MODIFICATION REQUEST:

**Concept Plan Application for Mixed Use
Development at Kirrawee Brick Pit**

MP10_0076 MOD3

Secretary's Environmental Assessment Report
Section 75W of the
Environmental Planning and Assessment Act 1979

Figure 5: Approved (top) and proposed modified (bottom) concept plan layout and scale (Source: proponent's RtS)

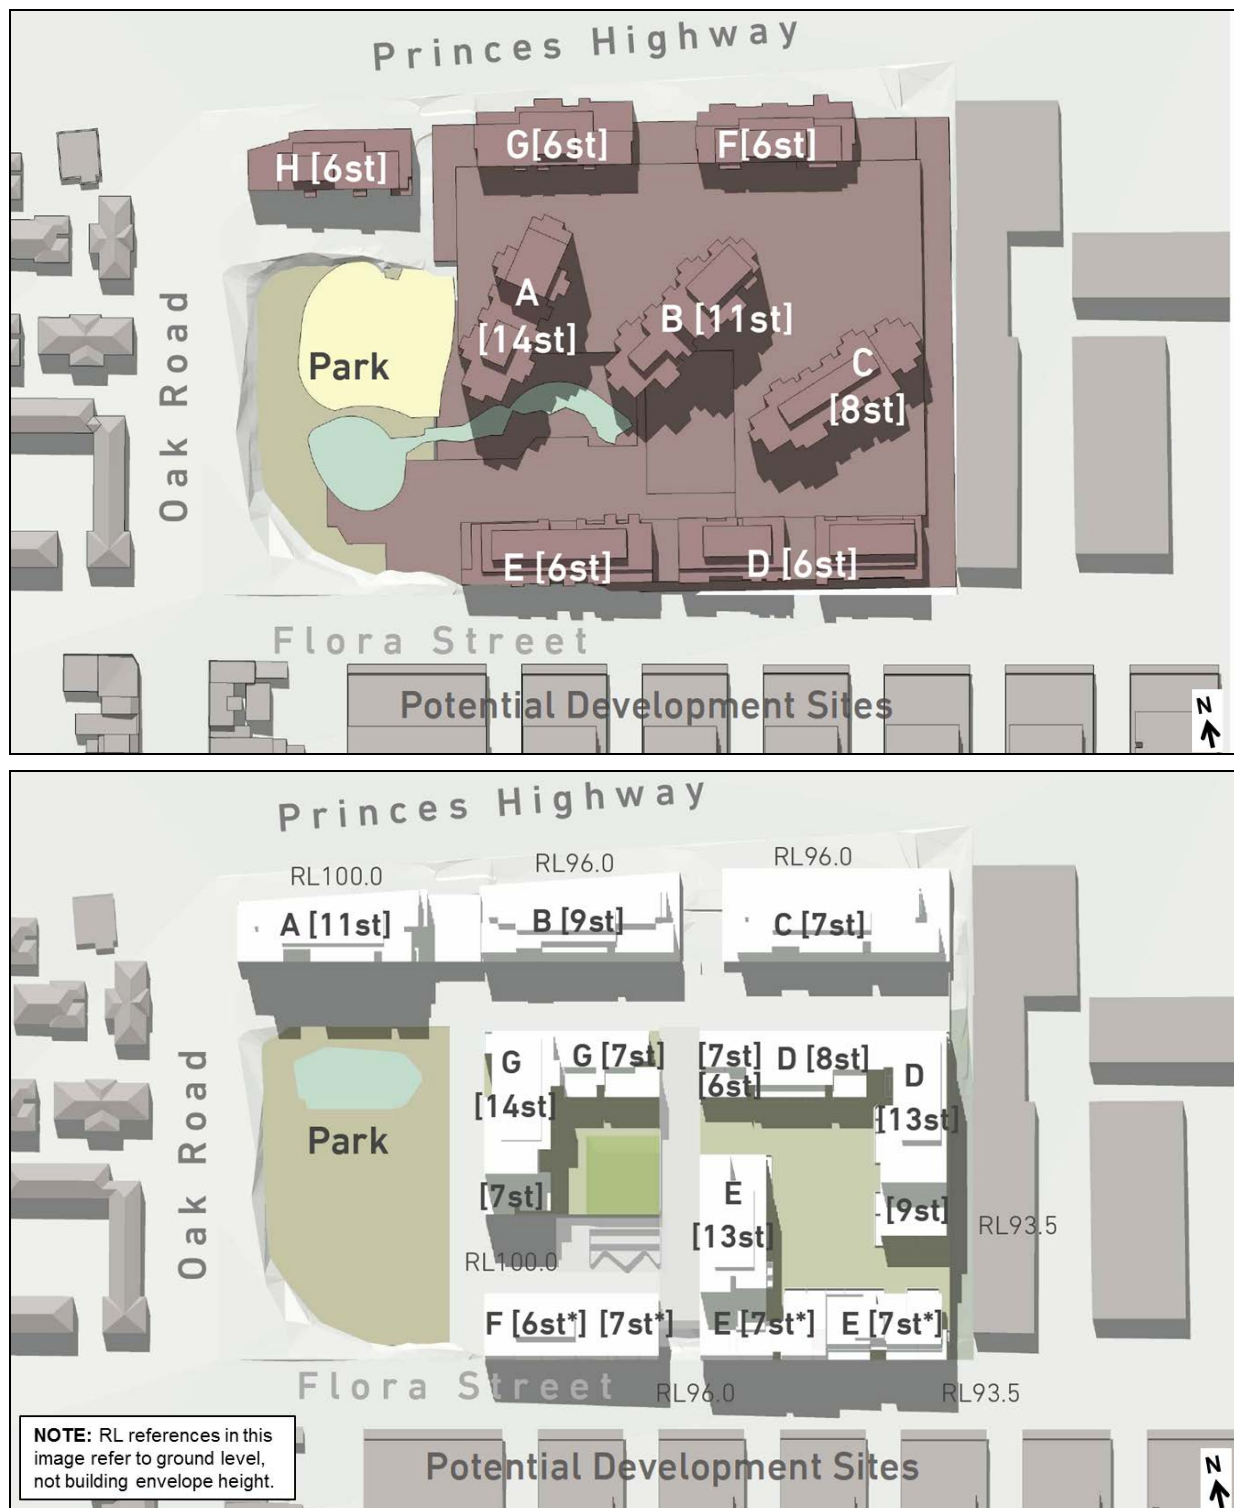
The Department notes that the application originally proposed 11 and 14 storey building envelopes (E and F) fronting Flora Street. The application has since been amended on two occasions in response to Council's and the Department's concerns about the height of these building envelopes and the application now proposes an increase of an additional storey (setback from the building edge).

At the eastern boundary of the site, the original concept plan includes the provision of a seven metre high retail podium above which are two buildings (six and eight storeys) that occupy approximately 25% of the total boundary length. By comparison the proposal includes a 15 metre high retail podium above which are three buildings (ranging in height from seven to 13 storeys) that occupy approximately 75% of the total boundary length (refer to **Figure 5**).

The concept approval includes three 6 storey building envelopes fronting the Princes Highway. The proposal seeks to amend the building envelopes (A, B and C) by increasing their footprints and also their height from 6 storeys to 7, 9 and 11 storeys (refer to **Figure 5**).

It is the Department's view that the provision of two 7 storey building envelopes (with setbacks) fronting Flora Street is acceptable for the following reasons:

Figure 6: Overshadowing of Flora Street by the approved (top) and modified proposed (bottom) development (Source: proponent's RtS)

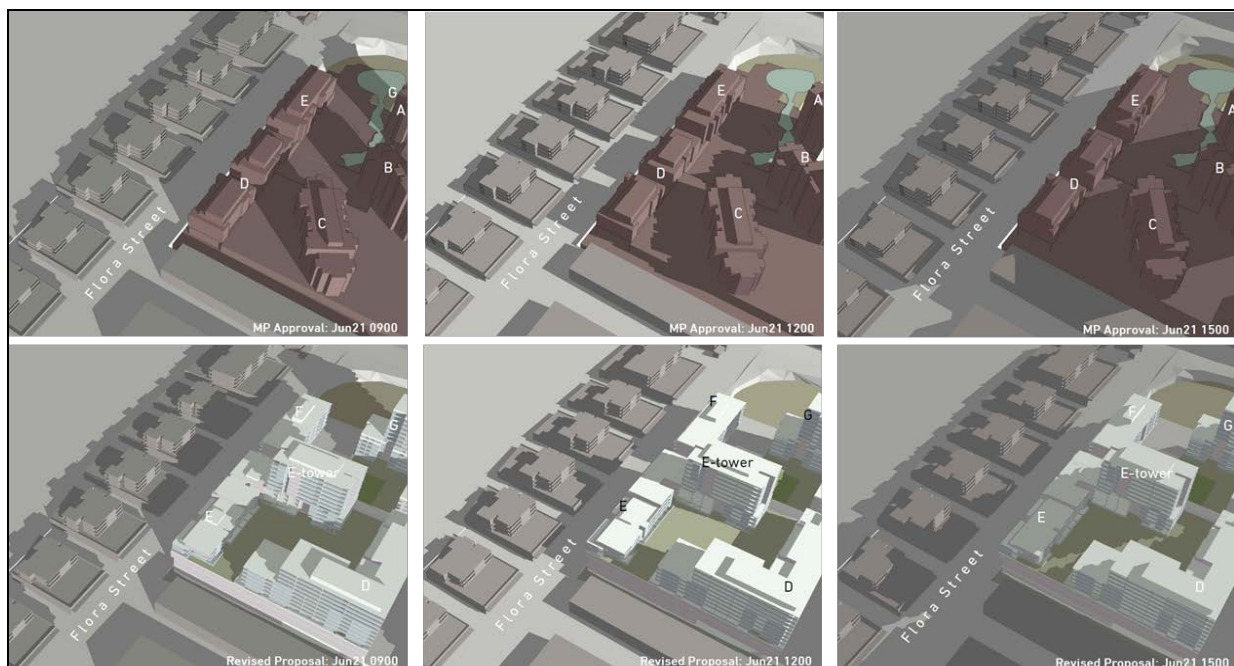
- the proponent's solar access analysis has confirmed that building envelopes E and F would not cast significant shadows over the development sites on the southern side of Flora Street. The Department therefore considers that the inclusion of an additional storey would not jeopardise the redevelopment potential of those sites (refer to **Figure 6**).
- Council's Development Control Plan and draft LEP 2013 envisage 5 storey (16m) buildings to the southern side of Flora street. The Department does not consider that the scale of the proposed buildings on the northern side would appear overbearing or out of scale in that context.

Figure 7: Relationship of the proposed modified concept plan to the Eastern Site (Base source: proponent's RtS)

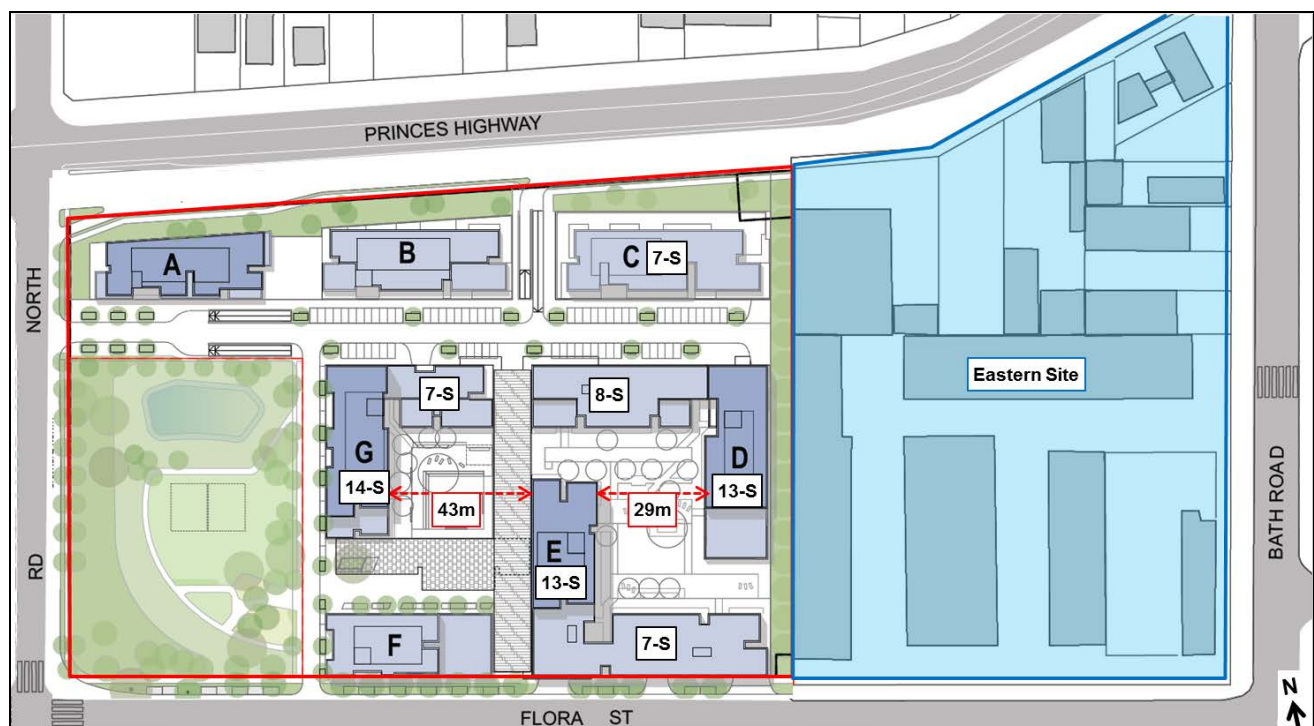
- if approved in its current form Council would be compelled to review the draft LEP 5 storey height control for the Eastern Site; and
- the 13 storey building should include a 12m setback at level 5 and above to provide an equitable approach to achieve the recommended 24m separation between buildings that exceed 25m in height (in the Residential Flat Design Code (RFDC)).

The Department notes that the proposed modification provides for tall buildings (11, 13 and 14 storeys) adjacent to lower rise buildings (6, 7 and 8 storeys) and this variation in scale establishes a site-wide building scale hierarchy. Further, the proposal provides for a minimum building separation of 29 metres between the 13 storey building envelopes and that these taller buildings have a staggered layout to prevent tower crowding (refer to **Figure 7**).

The Eastern Site is a similar size to the concept plan site and it is reasonable to expect that the development of the Eastern Site may adopt a similar approach to tower separation distances (rather than the absolute minimum of the RFDC) and prevention of crowding. This being the case, the Department concludes that the development of that site would not be unreasonably jeopardised by the proposed nine metre (rather than 12 metre) setback along the shared boundary as:

Figure 8: Indicative building (building envelope A) located on the corner of Oak Road North and the Princes Highway (Base source: proponent's RtS)

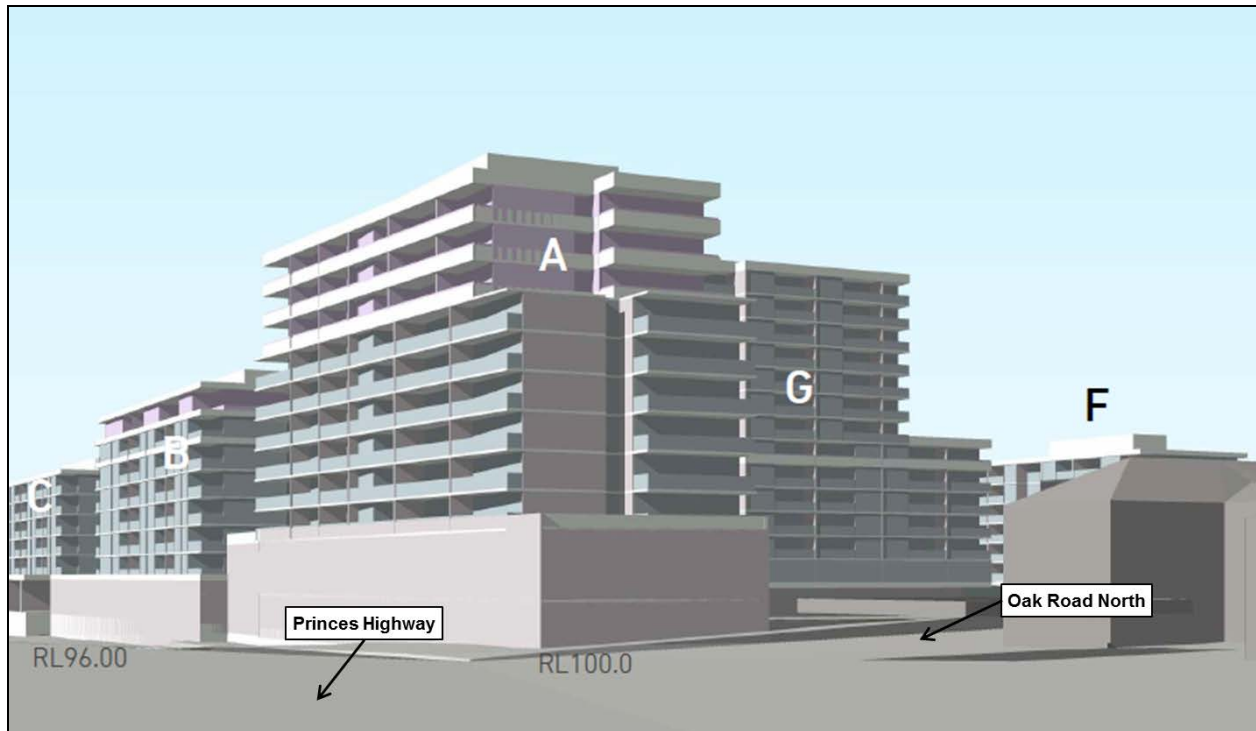
The Department notes that the proposed height of building envelope A was reduced by two storeys (from 13 to 11 storeys) in response to the Department's concerns about its scale and relationship to neighbouring properties (**Figure 8**).

The corner of Oak Road North and Princess Highway is a prominent corner and forms the principal entry into the Kirrawee Town Centre. In such circumstances a taller building is considered appropriate to strongly announce the corner and establish an identifiable visual marker that appropriately reinforces this important entrance.

The Department acknowledges that the resulting building would present a larger scale than the existing surrounding buildings, however the 11 storey building is considered to relate appropriately to the rising stepped heights of Buildings B and C and also the greater scale of development located centrally within the site. The Department notes that the amended/reduced height of the building envelope from 13 to 11 storeys has ensured that there is no adverse overshadowing of neighbouring residential properties (refer to **Figure 10**). The impact of building envelope A on the open space and the lake is discussed further at **Section 5.4**.

Figure 9: Concept approval (top) and proposed (bottom) STIF to be retained and provided onsite (Base source: MP10_0076 and proponent's RtS)

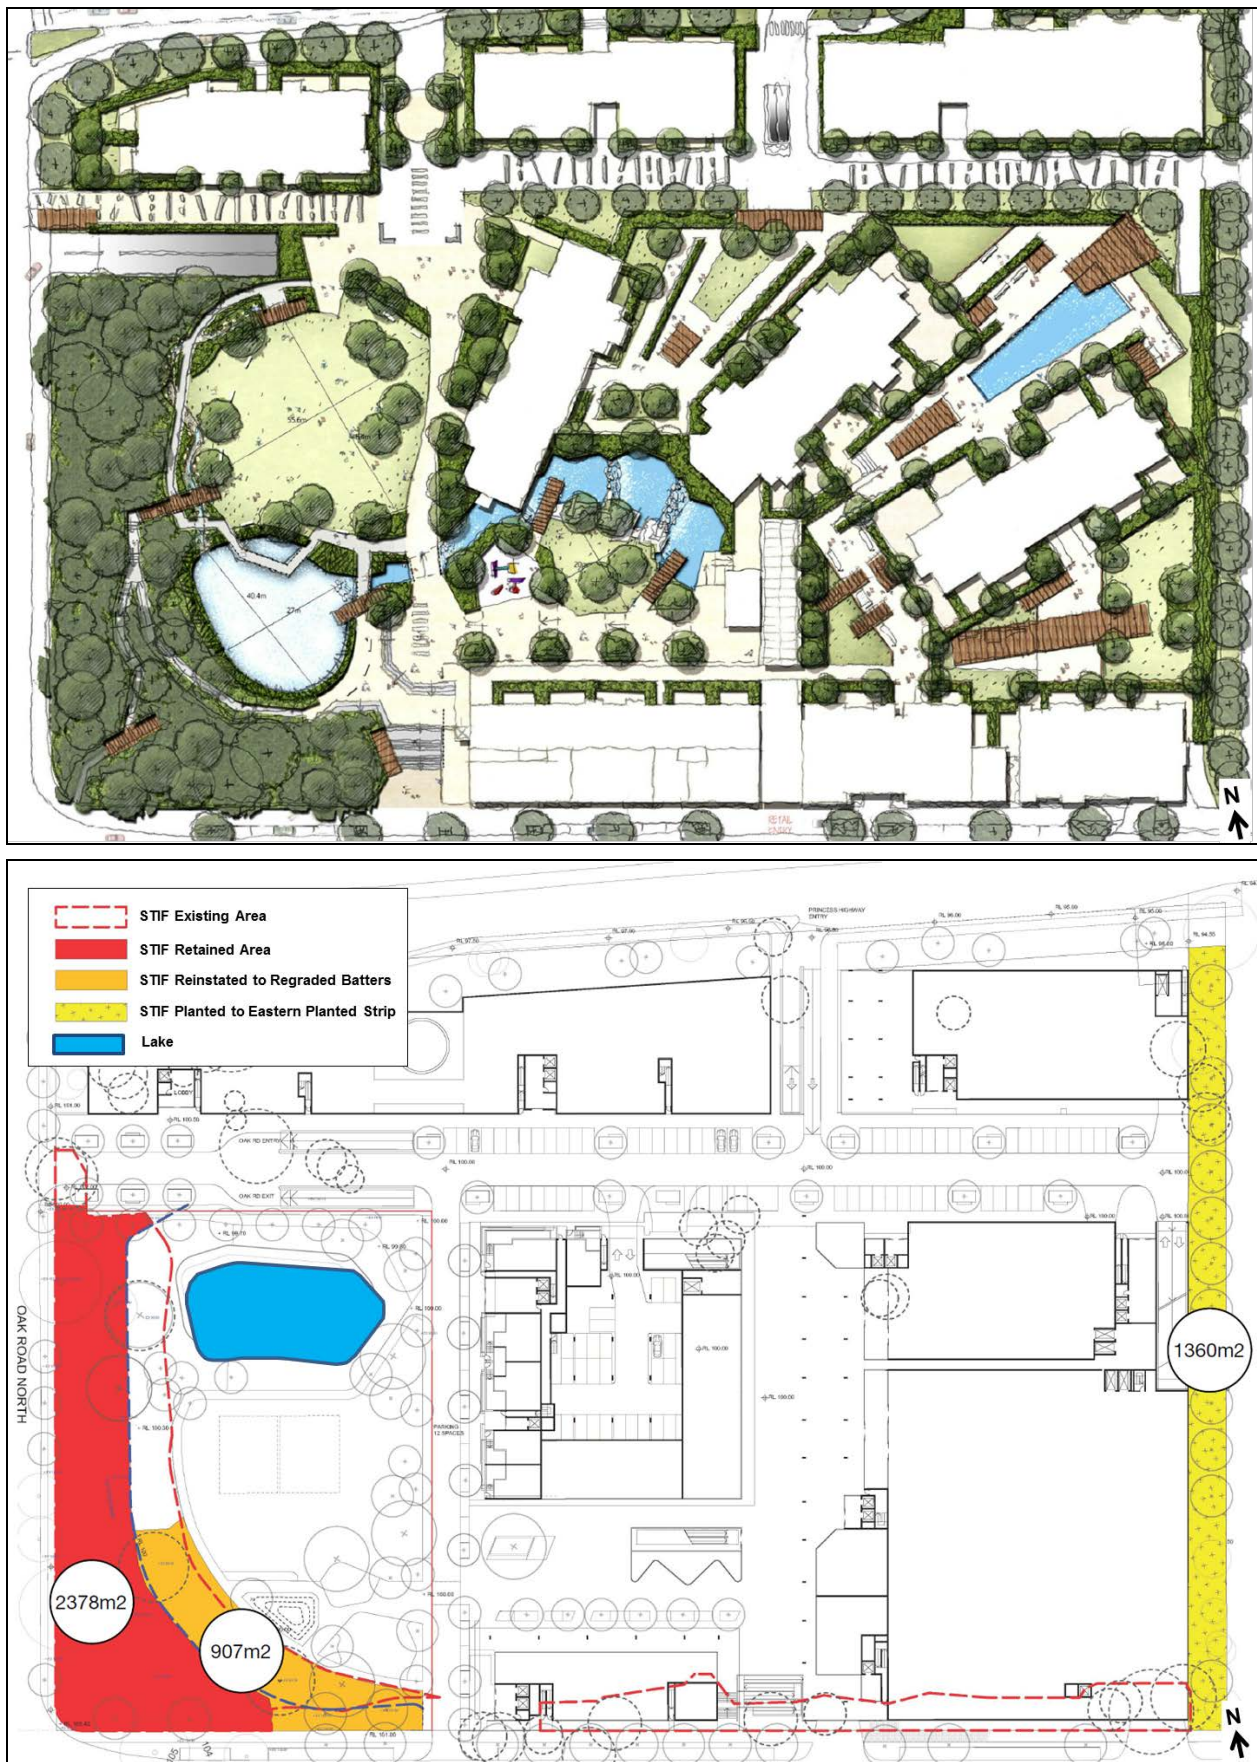
The Department notes that Term of Approval A11 requires that the design of the open space be 'generally in accordance with the plans and documents' (which include the landscaping plan shown at **Figure 9**). The approved landscaping plan is conceptual in nature and not a detailed plan. However, it clearly divides the open space into three segments, being STIF along the western boundary, a lake at the southern end of the open space and open grassed area at the northern end of the open space.

The proposed modification includes an amended landscaping plan which amends the location of the lake and the open grassed area. The proponent states that the:

In light of the above, and with reference to the Department's original assessment of the open space, the Department considers that there is merit for the location of the lake in either the

northern and southern end of the open space. The Department also notes that the proposal is at conceptual stage and therefore would be subject to future design development. Consequently, to ensure that the design options for the open space are not unreasonably limited, the Department recommends that Term of Approval A11 be amended to allow for the location of the lake at either the northern or southern end of the open space. The Department also recommends that a vegetation management plan be prepared for the open space with the future detailed development application.

Figure 10: The shadow cast by Building A over the open space, relocated lake and neighbouring residential properties (Source: proponent's RtS)

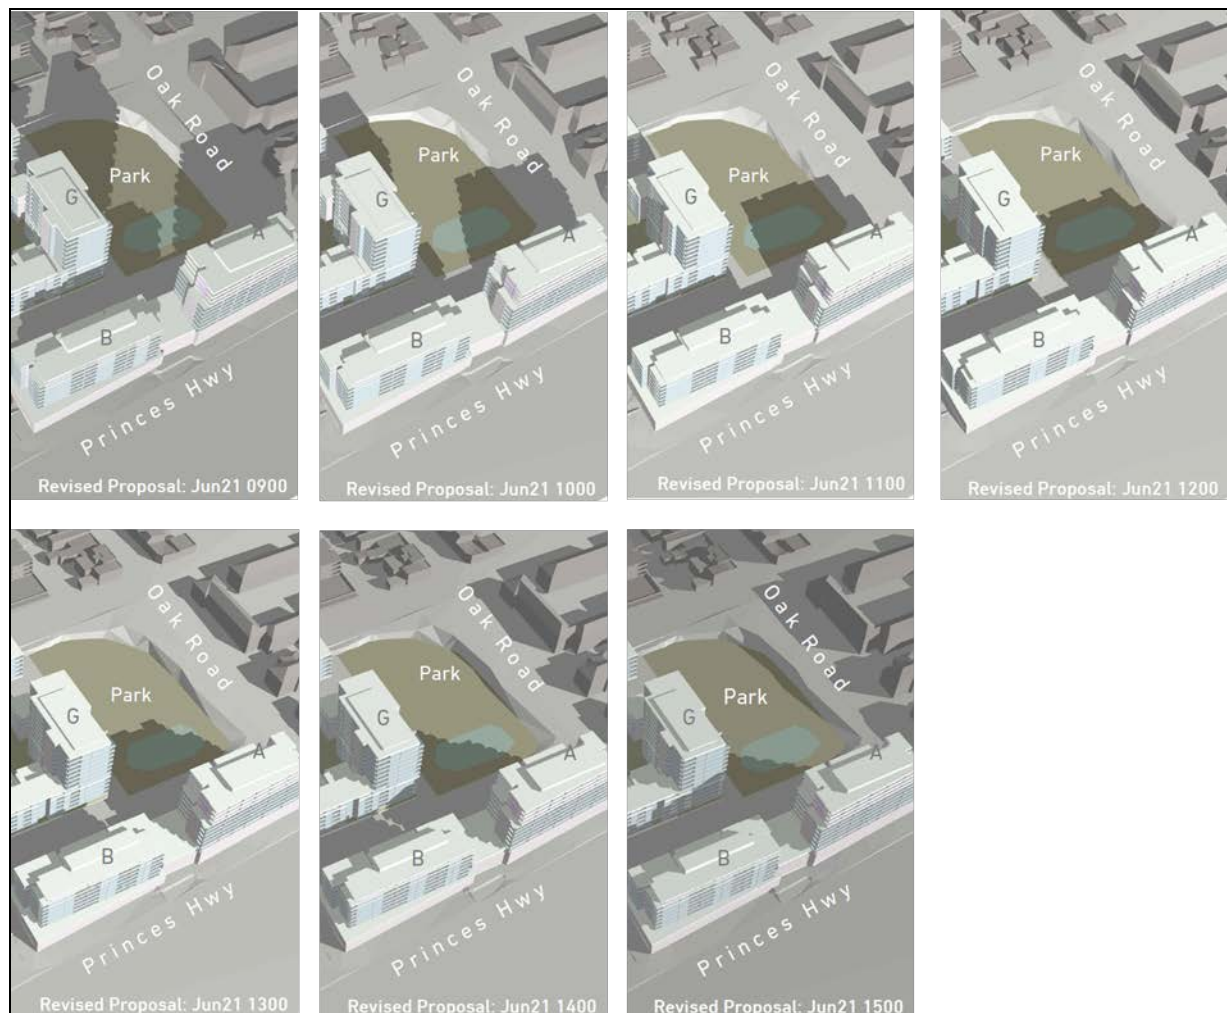
NOW has raised concerns about the impact of the height of Building A on the vegetation to be established around the lake and long term growth of wetland plants. NOW also recommended that a vegetation management plan be provided.

- the lake would only be fully overshadowed for a short period at midday during mid-winter. At all other times of the day and year the lake will receive solar access (refer to **Figure 10**);
